Project	<b>IEEE 802.16 Broadband Wireless Access Working Group</b> < <a href="http://ieee802.org/16">http://ieee802.org/16</a> >	
Title	<b>Text Clean-Up For MAC Feedback Header</b>	
Date Submitted	<b>2005-05-01</b>	
Source:	Sean Cai, Mary Chion	<a href="mailto:scai@ztesandiego.com">scai@ztesandiego.com</a>
	<b>ZTE San Diego Inc.</b> 10105 Pacific Heights Blvd. San Diego, CA 92121 USA	Voice: 858-554-0387 Fax: 858-554-0894
Re:	Response to Sponsor Ballot on IEEE802.16e/D7 document	
Abstract	To text clarification and clean-up regarding MAC Feedback header	
Purpose	To incorporate the text changes proposed in this contribution into the 802.16e/D8 draft.	
Notice	This document has been prepared to assist IEEE 802.16. It is offered as a basis for discussion and is not binding on the contributing individual(s) or organization(s). The material in this document is subject to change in form and content after further study. The contributor(s) reserve(s) the right to add, amend or withdraw material contained herein.

# Text Clean-Up For MAC Feedback Header

Figure 20e—MIMO Channel Feedback header with CID field

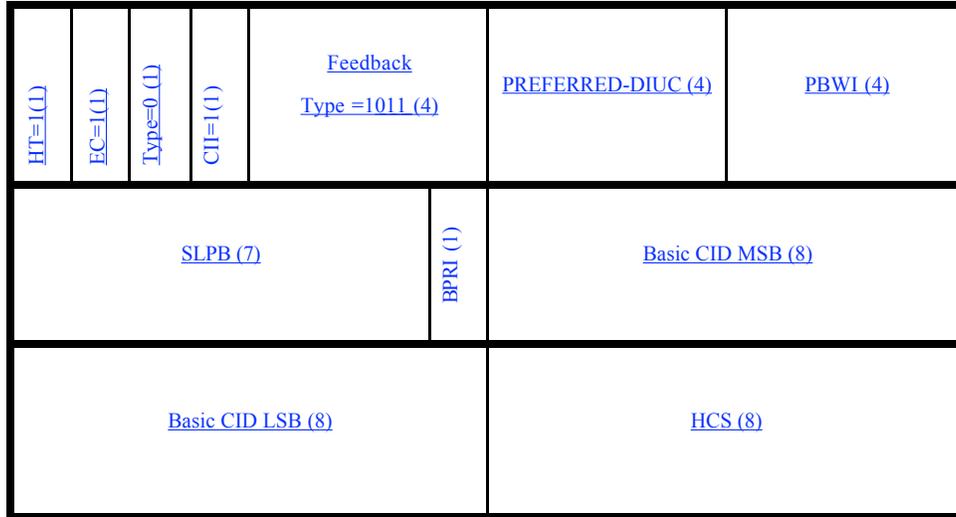
[Replace drawing in Figure 20e on page 28 in p802.16e/D7 with the following drawing]

Figure 20f—MIMO Channel Feedback header without CID field

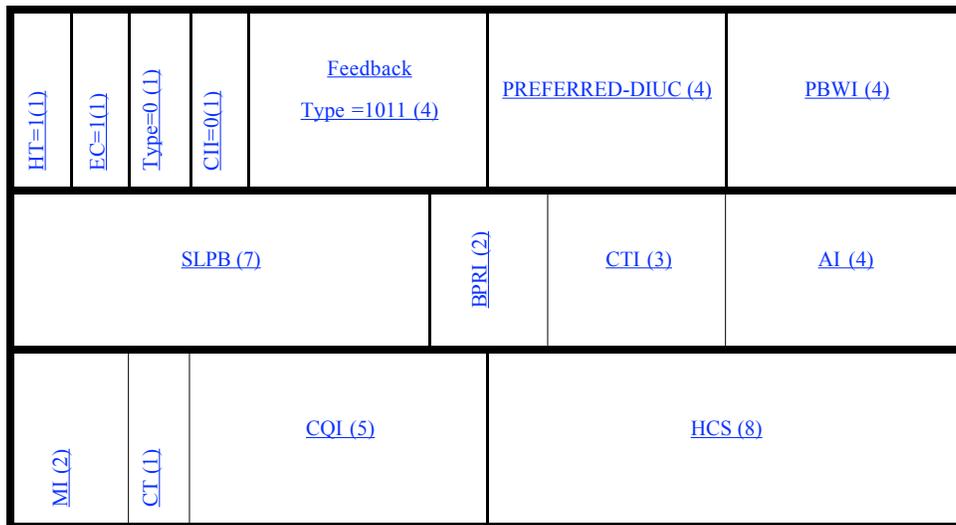
[Replace drawing in Figure 20f on page 28 in p802.16e/D7 with the following drawing]
